**MONTGOMERY COUNTY HISTORIC PRESERVATION COMMISSION**  
**STAFF REPORT**

<b>Address:</b>	99 Elm Avenue, Takoma Park	<b>Meeting Date:</b>	9/6/2023
<b>Resource:</b>	Outstanding Resource <b>Takoma Park Historic District</b>	<b>Report Date:</b>	8/30/2023
<b>Applicant:</b>	Clark Pettig & Liz Pardue (Richard J. Vitullo, Architect)	<b>Public Notice:</b>	8/23/2023
<b>Review:</b>	HAWP	<b>Tax Credit:</b>	N/A
		<b>Staff:</b>	John Liebertz

**PROPOSAL:** Alterations to non-historic rear addition, basement alterations, new patio construction, and door replacement.

**Figures 3 and 4: View of the existing side elevation (left) and the proposed side elevation (right) showing the raising of the hipped roof. Staff requests that the applicant corrects or clarifies the height discrepancy (circled in red) on the proposed side and rear elevations.**

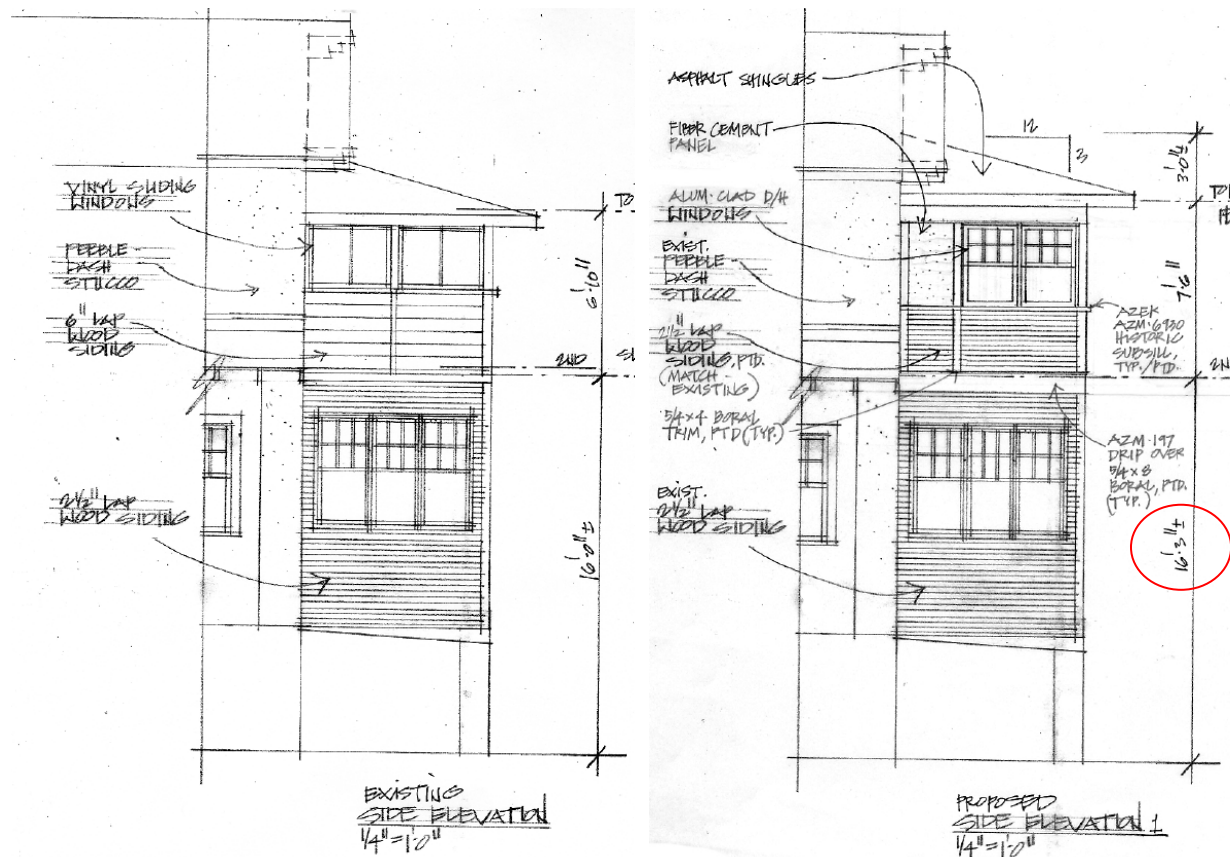
Staff requests that the applicant clarify the overall change in height of the enclosed sleeping porch. The existing side elevation shows that the height from grade to the top of the first story as 16' and the second story as 6'10", an overall elevation of approximately 22'10". The applicant proposed raising the second-story ceiling to 7'6" to meet current code requirements and increase usability of the space. The proposed side elevation shows the height from grade to the top of the first story as 16'3" and the second story as 7'6", with an overall elevation of approximately 23'9". However, the proposed rear elevation shows the height from grade to the top of the first story as 16'0" and the second story as 7'6", with an overall elevation of approximately 23'6". As there is a 6" difference between the elevation drawings, staff recommends approval of either change in roof height, but requests that the applicant update the drawings to rectify this discrepancy.

1. The applicant shall rectify and clarify the discrepancy in the overall change in height of the two-story, enclosed sleeping porch.
2. The applicant shall submit a detail for the proposed overhanging eave that shows its design and materials.
3. The applicant shall submit a note or window specification that illustrates that the proposed muntin matches the profile and width of the existing windows to the greatest possible extent.
4. The applicant shall submit a door specification for the basement and a detail of the proposed concrete stairwell.
5. The applicant shall submit a note that all cellular polyvinyl chloride and poly-ash trim will be painted.
